System Pillar / EULYNX

Baseline Set 4 Release 2

Version: 2
Date: 04-10-2023

Annex 1: Error correction CRs

[EUP-516] [Req. Spec. P: Incorrect IO Flow on SD 2.1.2.4.9 \(Eu.P.5804\) and 2.1.2.4.10 \(Eu.P.5374\)](#) Created: 10.08.2023 Updated: 10.08.2023

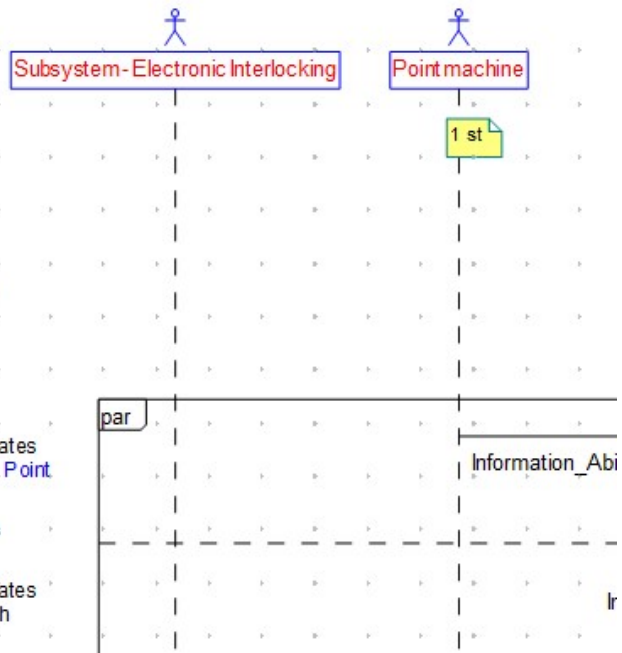
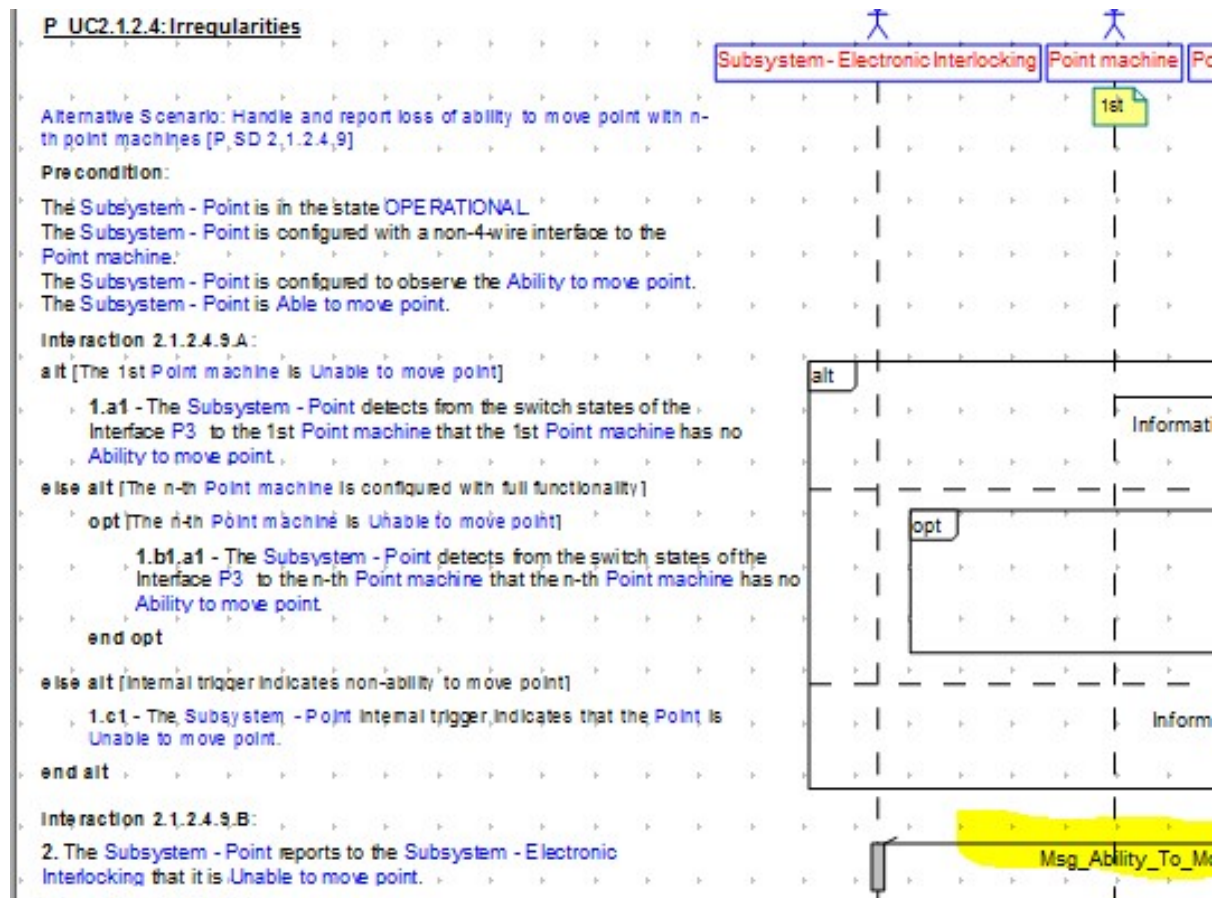
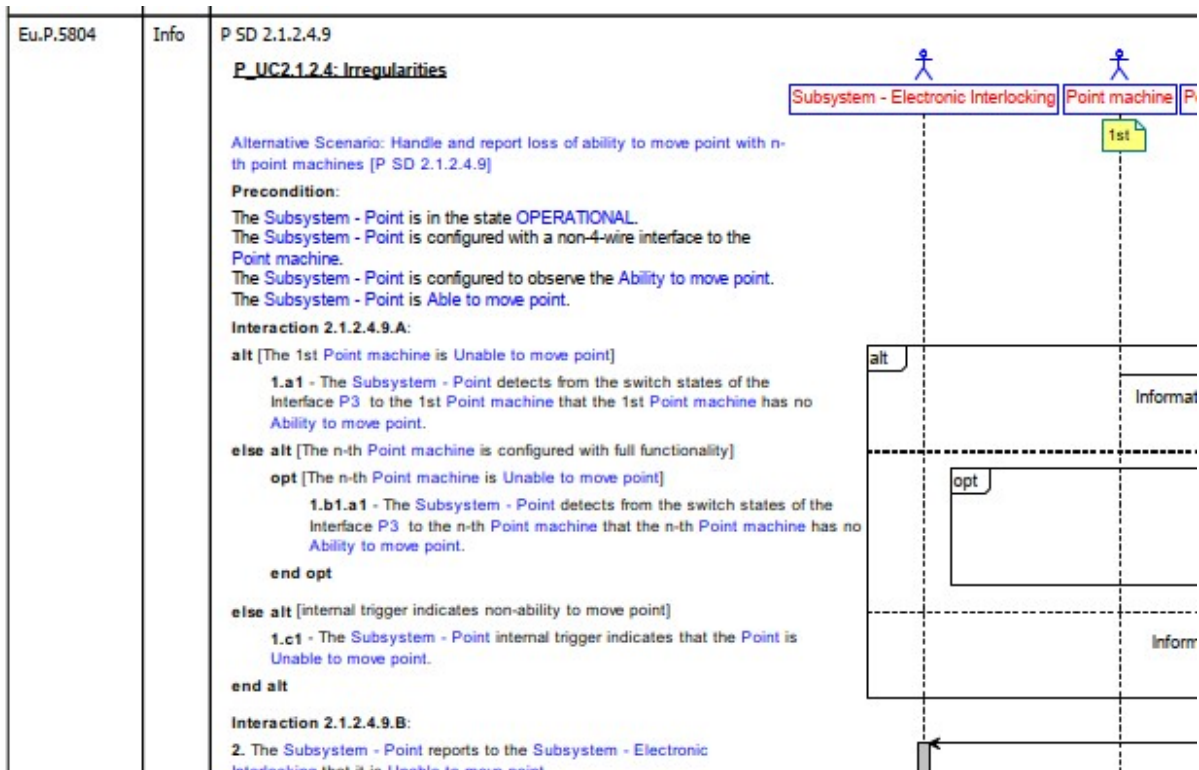
On SD 2.1.2.4.9 (Eu.P.5804) and 2.1.2.4.10 (Eu.P.5374) in on Step 2 a incorrect IO Flow is used (Msg_Point_Position).

Msg_Ability_To_Move_Point should be used.

Corrected in PTC. Sync, Ticketed marking needed.
